Service Bulletin No.: DA20-73-03, Rev.2

Title: Automotive Fuel Conversion

2. Effectivity: DA20-A1 aircraft serial Number 10002 to 10092 equipped with ROTAX 912 A3 engines.

Figure 1

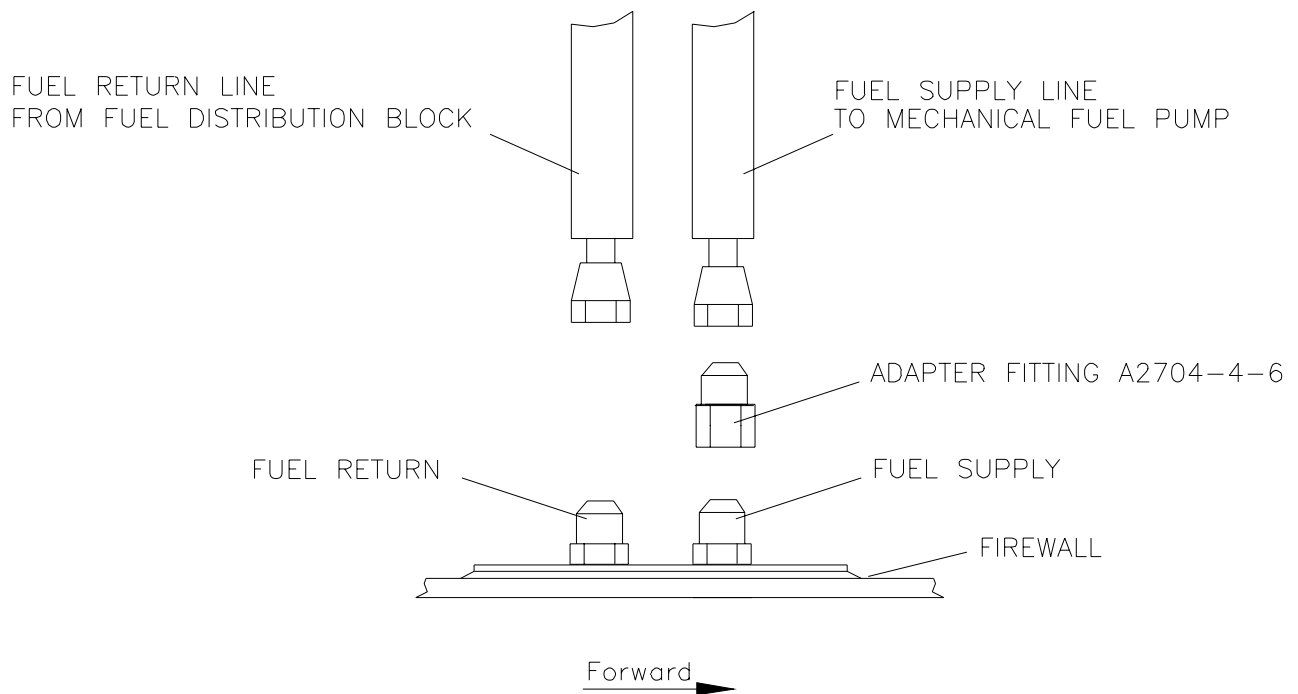
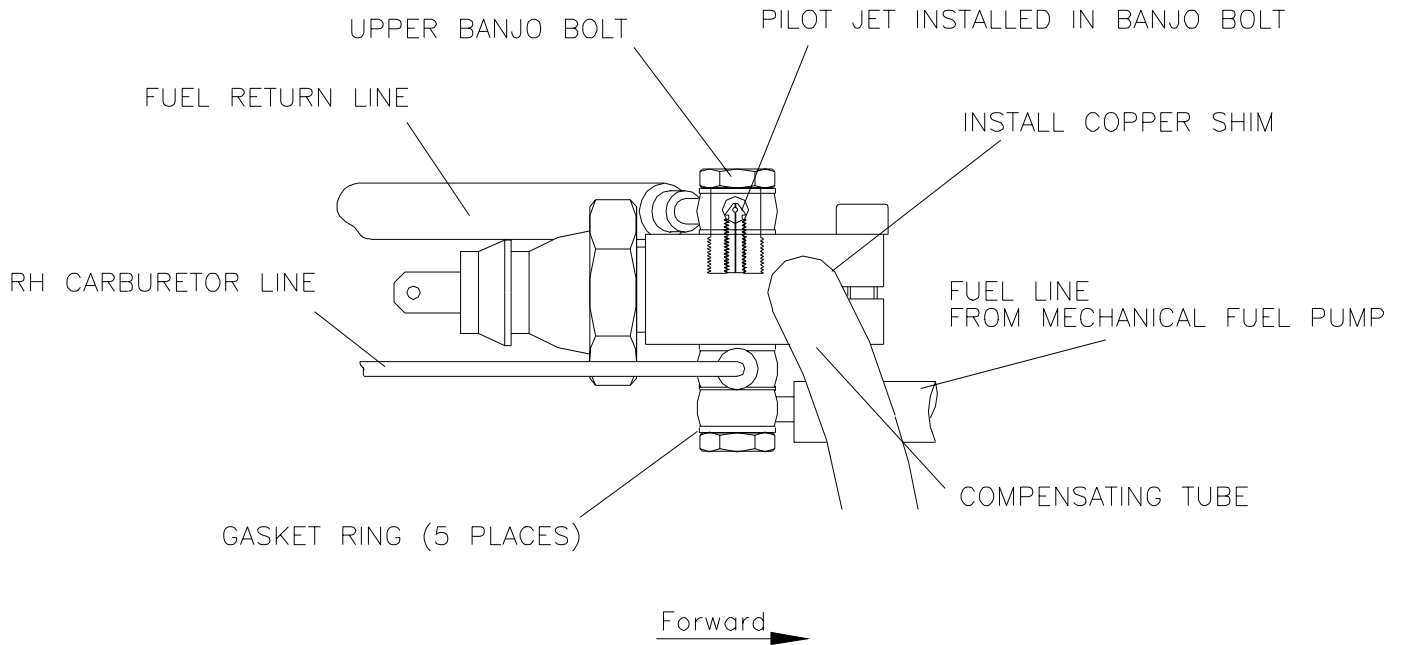
- NOTE:** The upper banjo bolt has been fitted with a restricting orifice. **DO NOT** remove it.
- 10.18 Install the upper and lower banjo bolts, gasket rings and fuel return line to the distribution manifold, see figure 1.

- 10.19 Torque the gear box cap screw attaching the bracket to 90 in.lb (10 Nm)
- 10.20 Tie the fuel hoses as shown in figure 3.
- 10.21 Connect the fuel supply and return lines at the firewall fittings, see figure 1.

Figure 2

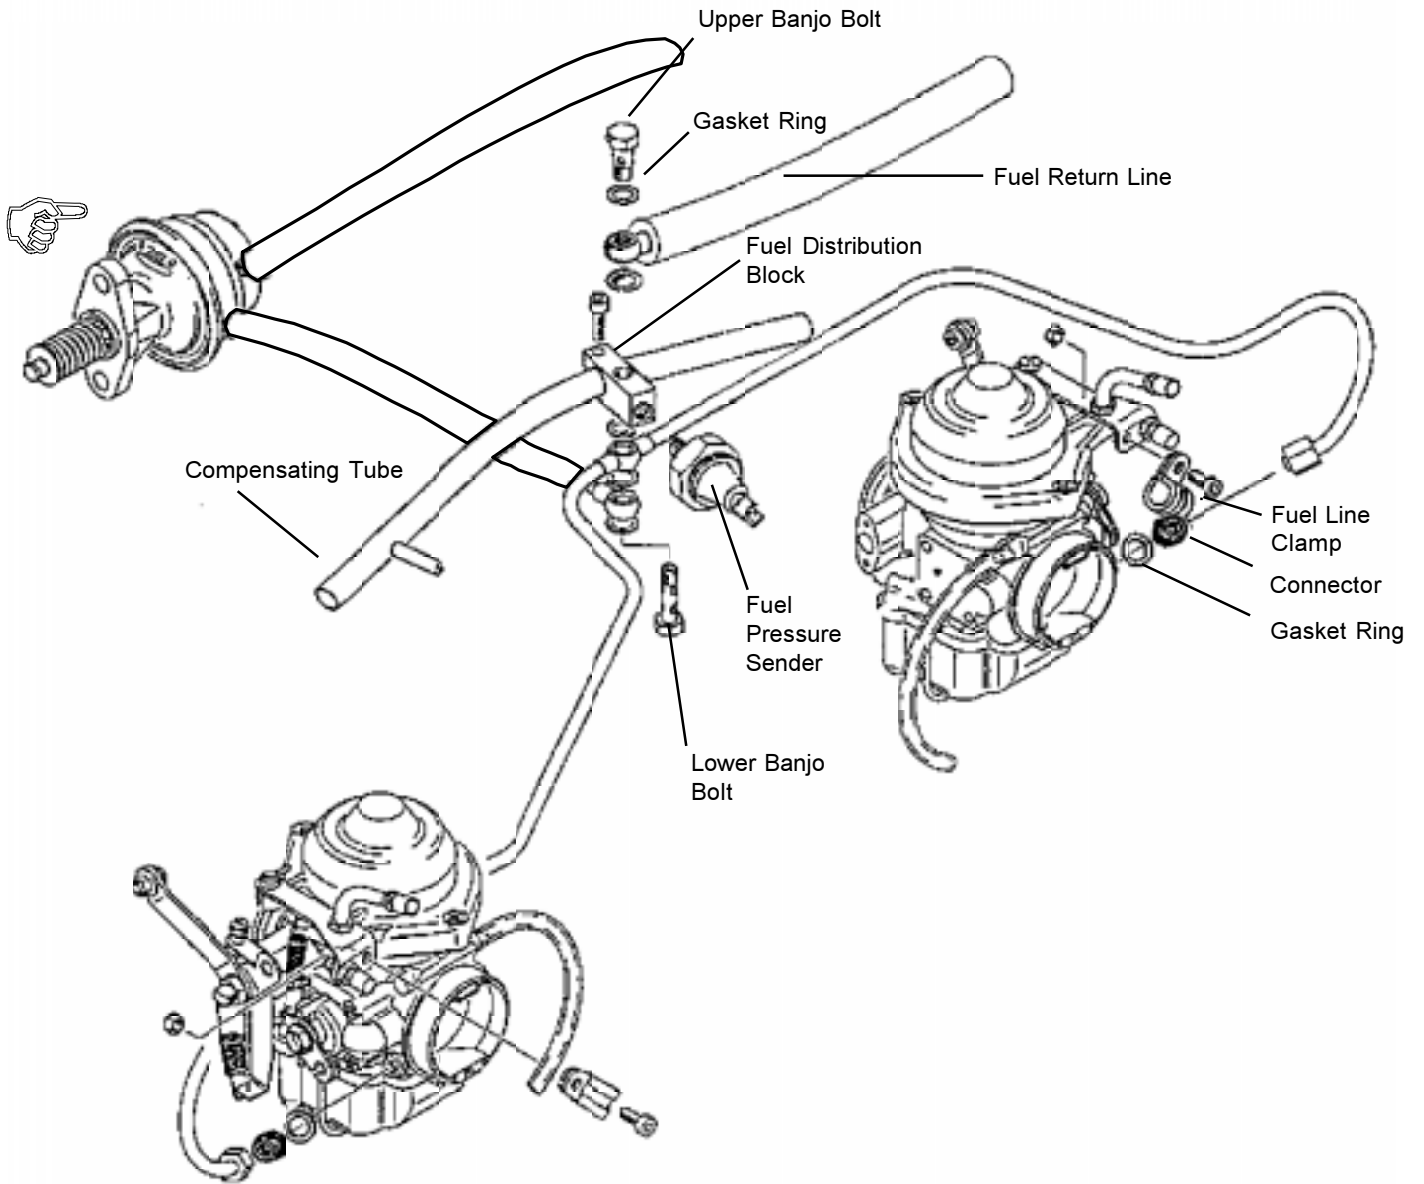
The steps listed below (which refer to engine components) provide only an order and direction in which to complete the fuel system conversion. Where the fuel system configuration differs from the ROTAX 912-F maintenance manual additional instructions are given, Refer to figure 1,2 and 3
